Access Compliance Report Public Rights-of-Way (Curb Ramps)

Intersection ID: 29462 Main Street: E_10TH_ST Cross Street: GARDEN_DISTRICT_DR Location: E

ADA ID: D60FE7BA9195 Ramp Type: Perp Initial Pass/Fail: Fail Overall Compliance: No Severity Score: 26.25

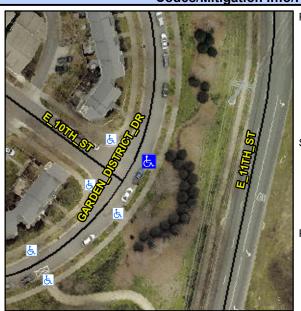
R304.2.2, R304.5.3

No N/A Ramp Length (in) 74.0 Ramp Slope (%) 140.0 No Ramp XSlope (%) Yes Ramp Width (in) N/A N/A Flare Type LT N/A Flare Type RT N/A N/A N/A Flare Slope RT (%) Flare Slope LT (%) N/A Flare Traversable LT? N/A N/A Flare Traversable RT? N/A N/A N/A DWS Provided? Landing Length (in) N/A Landing Width (in) N/A N/A **DWS Contrast?** N/A N/A N/A Landing Slope (%) DWS Length (in) N/A Landing X Slope (%) N/A N/A DWS Full Width? N/A Landing Curb? (Y/N) N/A N/A DWS Offset (in) N/A N/A Shared Landing? N/A **Gutter Ponding?** N/A N/A Gutter Slope (%) N/A Gutter Lip Ht (in) N/A N/A Gutter X Slope (%) N/A Painted X Walk1? No N/A Painted X Walk2? X Walk 1 Direction To NW X Walk 2 Direction N/A N/A X Walk 1 Width (in) X Walk 2 Width (in) X Walk 1 Slope (%) 5.3 X Walk 2 Slope (%) X Walk 1 X Slope (%) 4.1 X Walk 2 X Slope (%) N/A N/A N/A Ramp inside XWalk2? Ramp inside XWalk1? Road Slope (%) N/A N/A Clear Space? N/A Road X Slope (%) N/A Clear Space to XWalk (in) N/A N/A Any Obstructions? N/A Storm Grate/Utility Hazard? **Obstruction Type** Storm Grate/Utility Type N/A

Possible Solutions:

Remove & Replace Entire Ramp.
